**AUTOMATIC VALVE**41144 Vincent Court
Telephone 810-474-6700Novi MI USA 48375-1924
Facsimile 810-474-6732**World Class Air Valves and Controls**

SUBJECT: 10CFR21 NOTIFICATION OF POTENTIAL DEFECT

CORRECTIVE ACTION
9622A

TEST NUMBER: PV-UTL-46

Figure 4

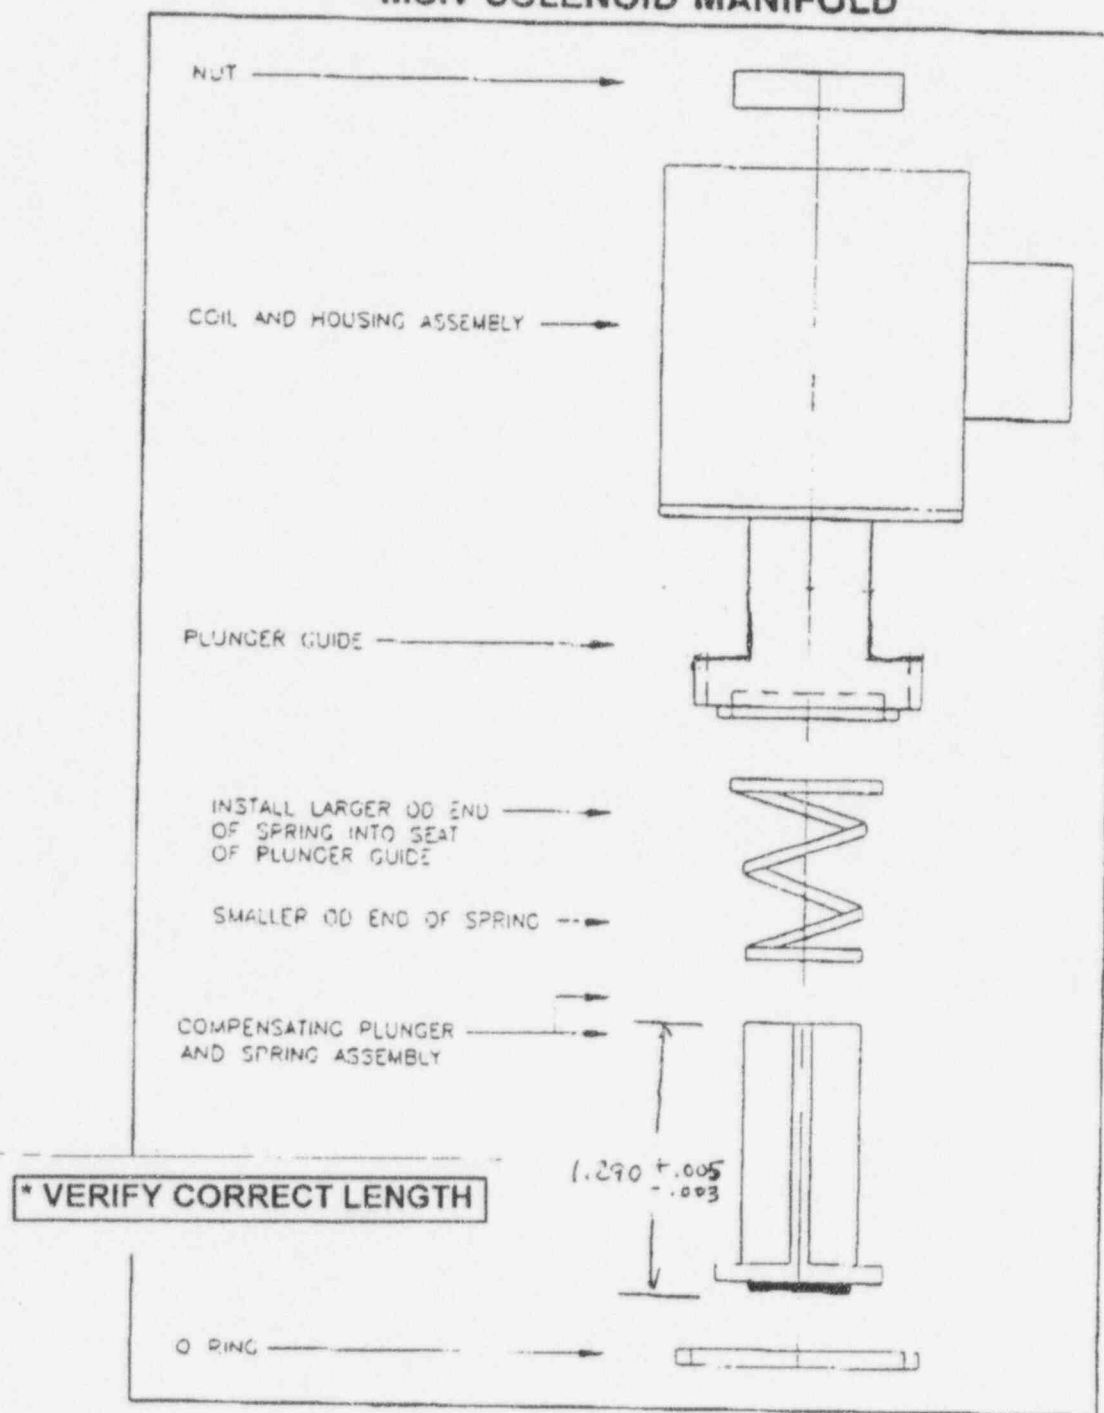
8.1 Plants should add plunger dimensions to field rebuild instructions (example attached).

RECOMMENDED FIELD REBUILD INSTRUCTIONS**MSIV SOLENOID MANIFOLD**
